# **City of Madison Fire Department**

SUBJECT:

149 E. Wilson St – McGrath Project and Marina Condominiums Fire Lane

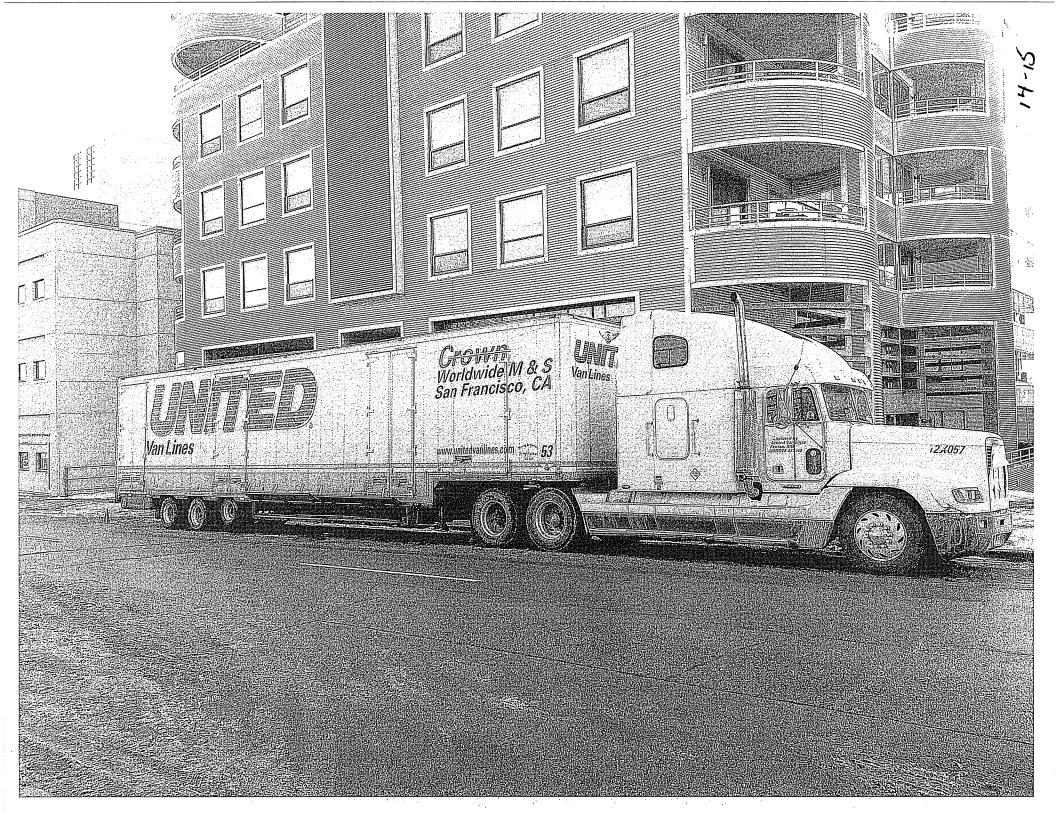
The 18-foot fire lane McMcGrath would reconstruct does not comply with code. I write to respectfully ask that you require the applicant to build at least a 20-foot wide fire lane at the proposed site.

The three buildings that would exist at 137 East Wilson St., 149 East Wilson St., and 155 East Wilson St. will make up one of the densest, if not the densest, acre in Madison outside of the UW campus area. It stands to reason that the Fire Department should execute the MCO and the IFC to its strictest minimum width of 20 feet, and perhaps significantly more. Because of traffic congestion along E. Wilson St. and the dozens of obstructions that are expected for move-in and move-outs of two buildings so close together with an excess of 180 units (see photo of a moving trailer in front of the Marina, taken by me on 1/14/14), arguably the Fire Department should require a fire lane wider than the minimum.

The code states fire lanes shall not be less than 20 feet wide. The intent of this width is to allow fire apparatus to pass in the fire lane. Since this is a dead end fire lane, there would be no reason for one fire apparatus to maneuver around another. At 18 feet wide, the fire lane will accommodate set-up of our largest fire apparatus (ladder truck with stabilizers deployed is 16 feet wide). In practice, the minimum width is also the maximum width. The fire department does not require property owners to exceed the minimums established in the code. To do so, may be perceived as arbitrary.

The proposed development and reconfigured fire lane will not have a negative impact on fire safety of the residents living in the Marina condominiums. Keep in mind, the fire lane must be re-constructed without the stairs infringing upon the minimum approved 18 feet width. The stairs are an unpermitted obstruction and must be addressed by the property owners of the Marina Condominiums. Please confer with the board to develop an plan and schedule for compliance.
